City of Boise ADA  
Assessment

# Appendix A-Fairmont Pool House

Report #TO20-B007

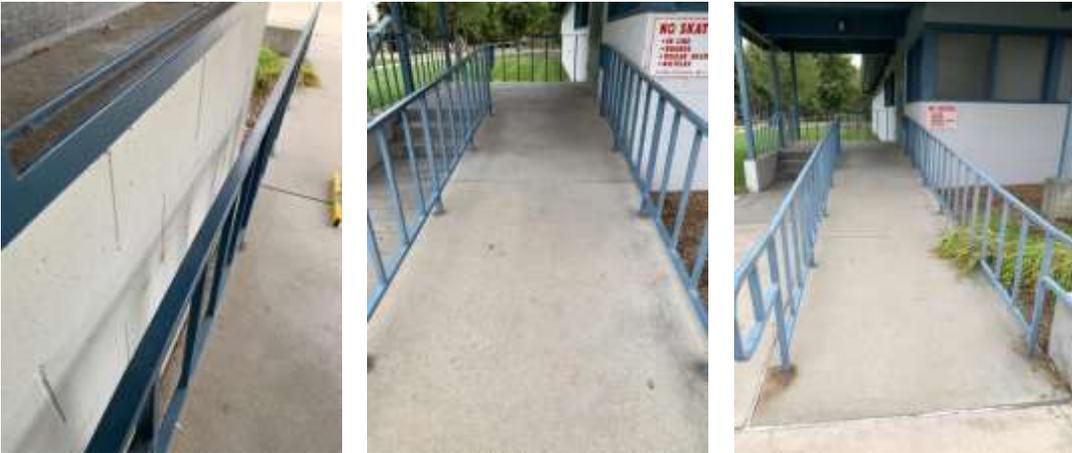
**2010 ADA Standards for Accessible Design Codes: §505.4**  
Handrails are not at a compliant height at 32" above the floor.

Raise the handrails to a minimum height of 34" and a maximum of 38" above the ground. Ensure that the handrails are at a consistent height along the walking surface.

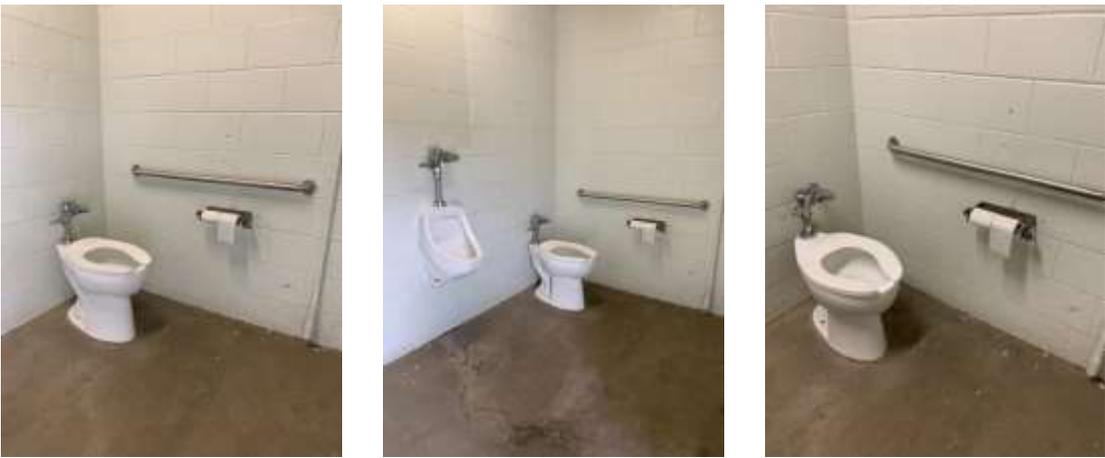
**2010 ADA Standards for Accessible Design Codes: ICC A117.1 §604.5.1**  
The accessible water closet does not have a vertical grab bar.

Install an 18" long (minimum) vertical grab bar, mounted with the bottom located at 39" minimum and 41" maximum above the floor.  
The centerline of the vertical grab bar shall be located 39" minimum and 41" maximum from the rear wall.

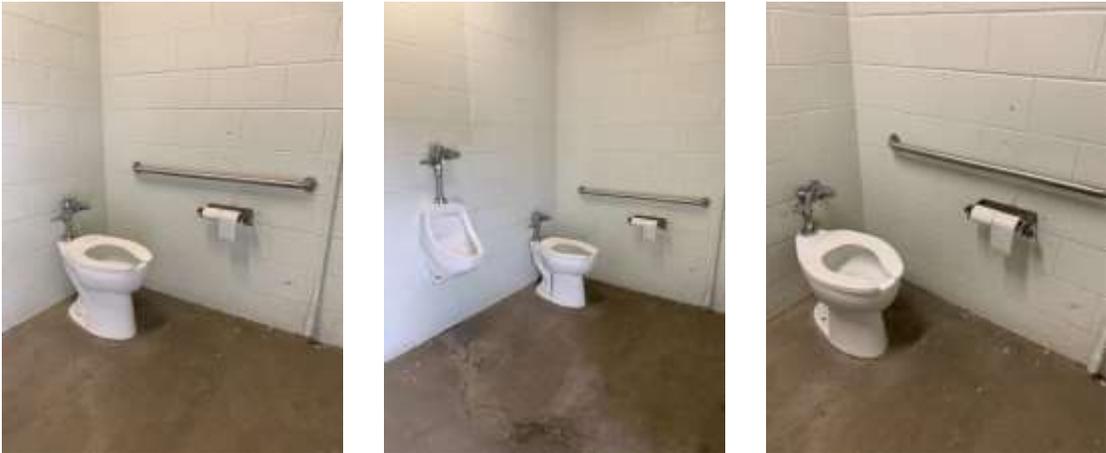
**2010 ADA Standards for Accessible Design Codes: §604.2**  
The toilet is located 20" from the sidewall.

Reposition the toilet to be within 16" minimum and 18" maximum from the sidewall.

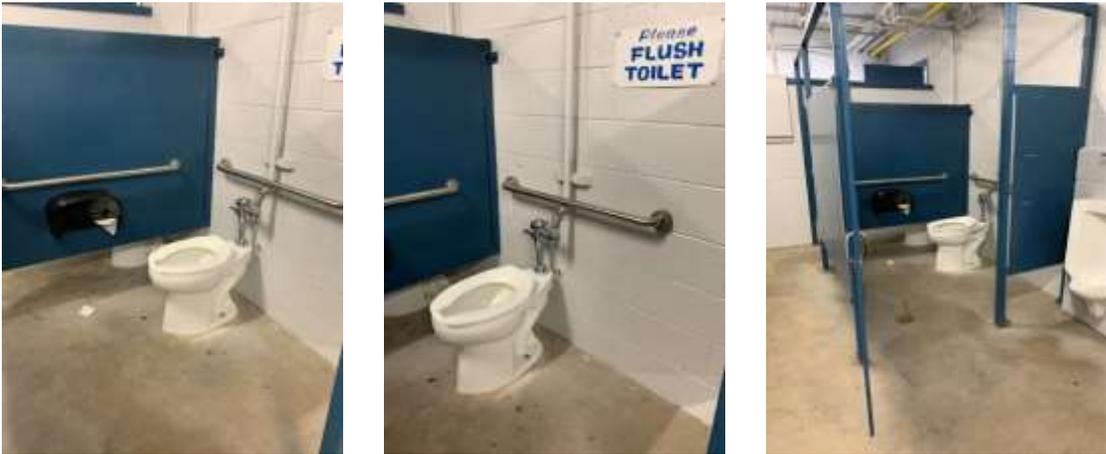
**2010 ADA Standards for Accessible Design Codes: §604.7**  
The toilet paper dispenser is not located in an accessible position.

Remount the toilet paper dispenser so that it is located 7" minimum to 9" maximum in front of the toilet. Ensure that the height is within the accessible reach range of 15" minimum to 48" maximum above the floor.

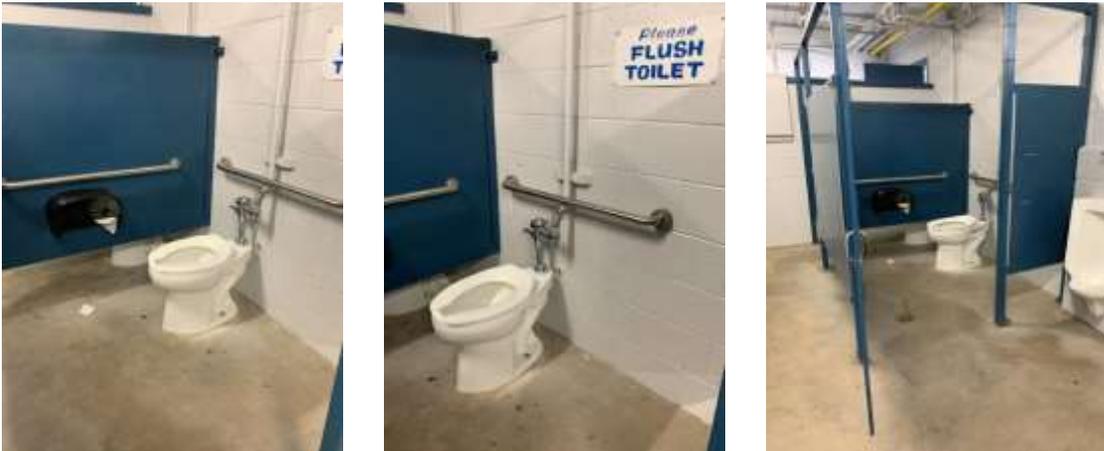
**2010 ADA Standards for Accessible Design Codes:** §604.5.1, ICC A117.1 §604.5.1  
The accessible water closet does not have a vertical grab bar.  
The side grab bar is located 12" from the rear wall and extends 53.5".

Install an 18" long (minimum) vertical grab bar, mounted with the bottom located at 39" minimum and 41" maximum above the floor. The centerline of the vertical grab bar shall be located 39" minimum and 41" maximum from the rear wall. Replace the side grab bar with one that is a minimum of 42" long, located 12" maximum from the rear wall and extending 54" minimum from the rear wall.

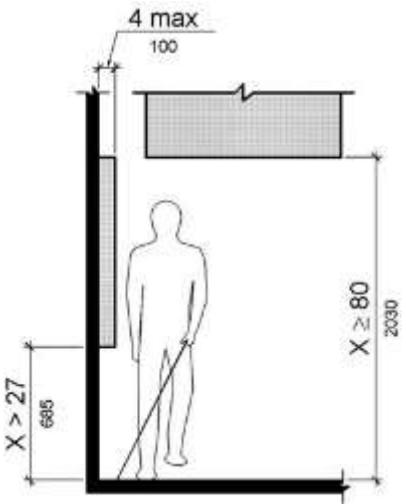
**2010 ADA Standards for Accessible Design Codes: §307.2**  
The fire extinguisher protrudes 4.5" into the circulation space at 34" above the floor.

Recess the fire extinguisher so it protrudes a maximum of 4", lower it so the bottom edge is 27" maximum above the floor, or place a cane detectable object beneath it.

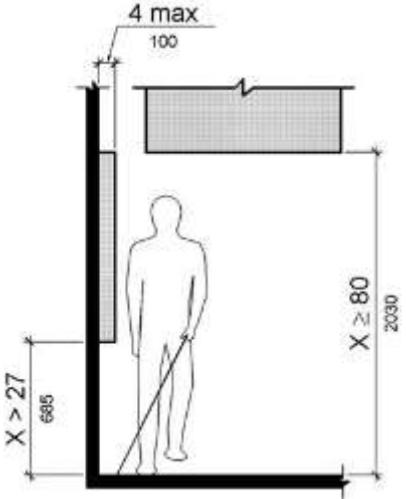
**2010 ADA Standards for Accessible Design Codes: §602, §307.2**  
The tall drinking fountain protrudes 17.75" into the circulation path.

Place a drinking fountain skirt at this location to provide cane detectability.

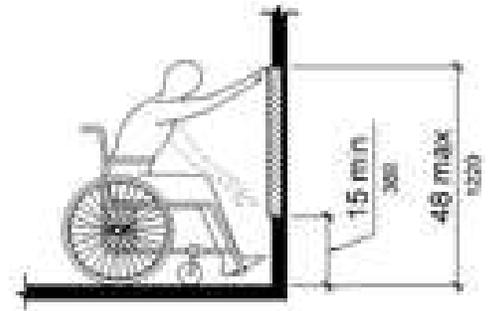
The hooks are outside of the unobstructed forward reach range at 67.5" above the floor.

Lower at least one hook by 19.5" to meet the accessible reach range of 15" minimum and 48" maximum above the floor.

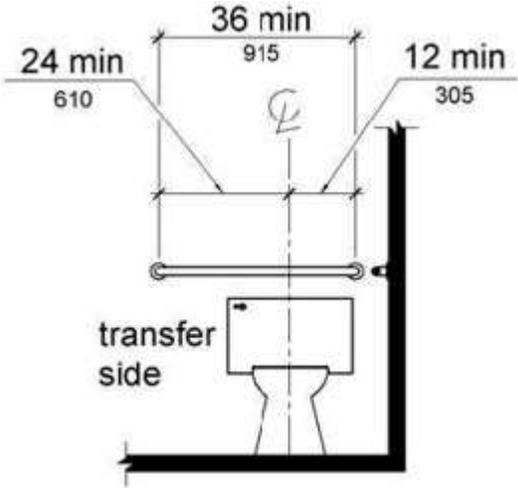
**2010 ADA Standards for Accessible Design Codes: §604.5.2**  
A pipe covers the rear grab bar.

Either split the rear grab bar or shift it to the open side of the toilet area per exception 2 in the 2010 ADA Standards.  
Where an administrative authority requires flush controls for flush valves to be located in a position that conflicts with the location of the rear grab bar, the rear grab bar shall be permitted to be split or shifted to the open side of the toilet area

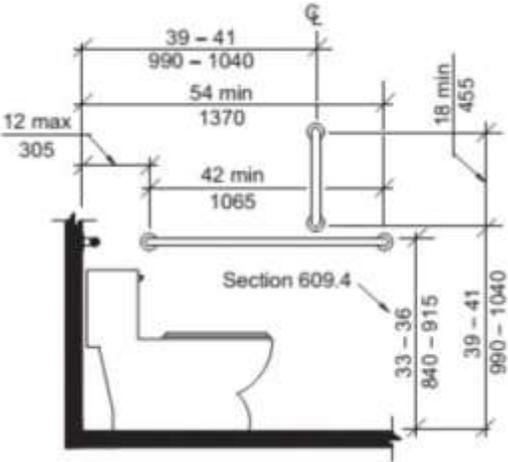
**2010 ADA Standards for Accessible Design Codes:** §604.5.2, ICC A117.1 §604.5.1  
There is no vertical grab bar, and the rear grab bar is 31" long.

Install an 18" long (minimum) vertical grab bar, mounted with the bottom located at 39" minimum and 41" maximum above the floor. The centerline of the vertical grab bar shall be located 39" minimum and 41" maximum from the re Replace the rear grab bar with one that is a minimum of 36" long minimum and extends from the centerline of the water closet 12" minimum on one side and 24" minimum on the other.
